## Development Review Committee Meeting

**March 4, 2026**  
**Development Review Committee Staff Comments**

**Bruin Road District PUD (PUD Master Plan):** A request by Kurt's Investments, LLC, for review of a Planned Unit Development (PUD) Master Plan application. The Applicant proposes a mixed-use development with associated infrastructure. The property is currently zoned Neighborhood Core-Historic District (NC-HD), Residential General (RG), and Neighborhood General-Historic District (NG-HD) and consists of approximately 7.26 acres identified by tax map numbers R610 039 00A 0024 0000, R610 039 00A 030B 0000, R610 039 00A 0030 0000, R610 039 00A 0048 0000, R610 039 00A 0026 0000, R610 039 00A 0027 0000, R610 039 00A 0029 0000, R610 039 00A 030D 0000, R610 044 000 0126 0000 located east of Bluffton Road north of Bruin Road. (MP-01-26-020087) (Staff - Dan Frazier)

Exhibit G (Transportation Impact Analysis) needs additional review and discussion.

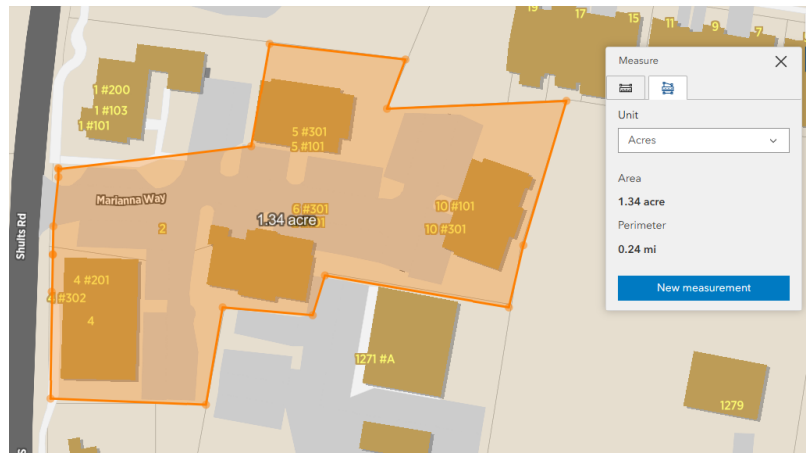
- a. No information is provided as to how the applicant came to a conclusion as to what is currently allowed in each district.
- b. The Traffic Consultant used a by-right count based on the site being able to accommodate 100 Multi-Family Units, 10,000 SF of Retail/Shops, 10,000 SF of Restaurant, 25,000 SF of General Office, 18 Single Family Residents and 18 Short Term Rental Units.

- c. The total project is 7.29 acres, of that 5.429 acres are zoned Residential General or roughly 74.4% of the site. Neighborhood Core-HD – 1.34 Acres = 18.3% of the Project & Neighborhood General-HD – 1.13 Acres = 15.5% of the Project. Based on the acreage **Staff believe that there could only be roughly 7,000 SF of Commercial and roughly 40 RDUs in the Historic District and 21 RDUs in the Residential General zoning district.**

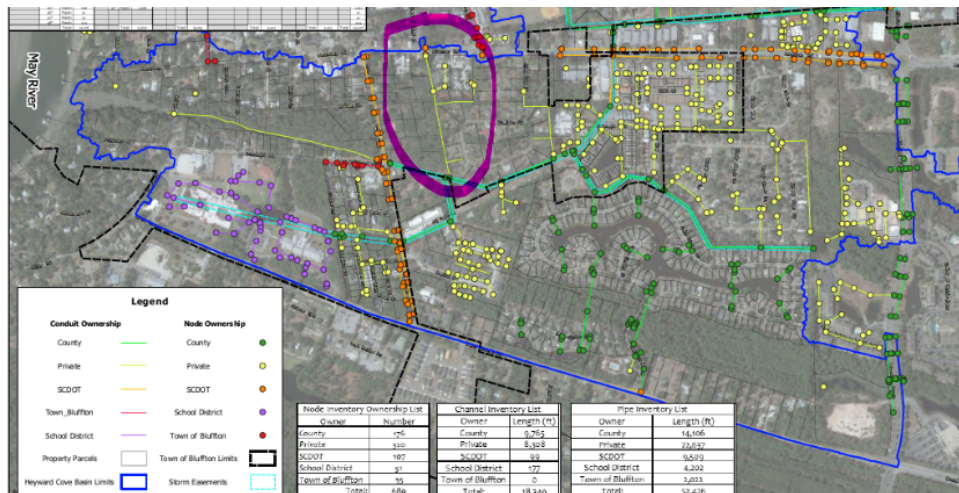
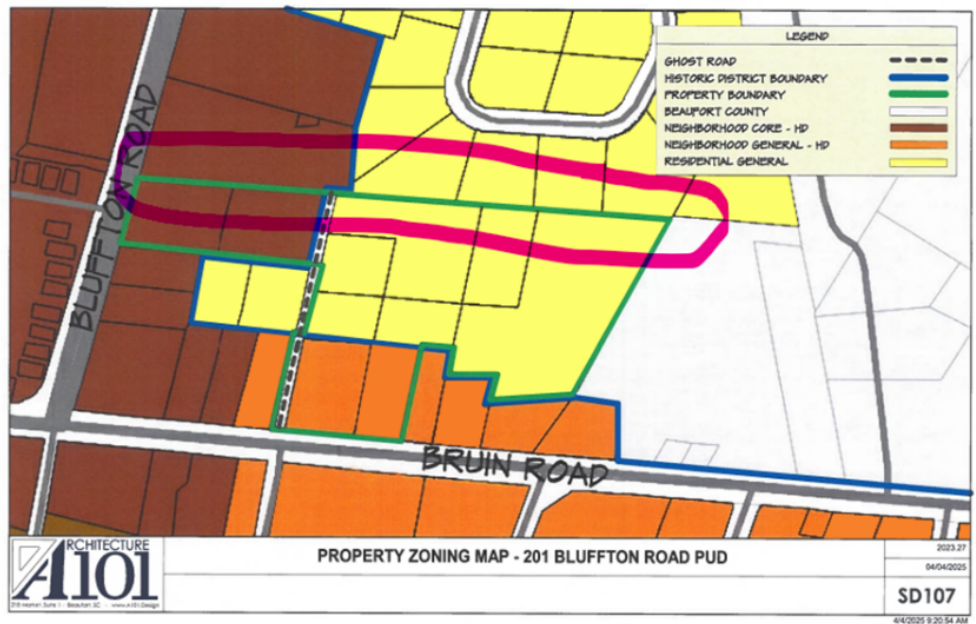
- d. The TIA needs to be updated to reflect actual by-right entitlements to accurately assess the impact of the proposed development request. Staff

does not agree with the TIA's By-Right assumptions included in the Project Trip Generation Summary.

- e. The TIA states that there is an assumption of a 48% internal capture rate. Please show where this is an acceptable amount. Typically you could estimate anywhere between 10-30%. Even at 30% that is for high-intensity mixed-use, which this is not.
- f. **TIA will be reassessed with Staff, our consultant and SCDOT to determine if improvements are needed as a result of the new document.**
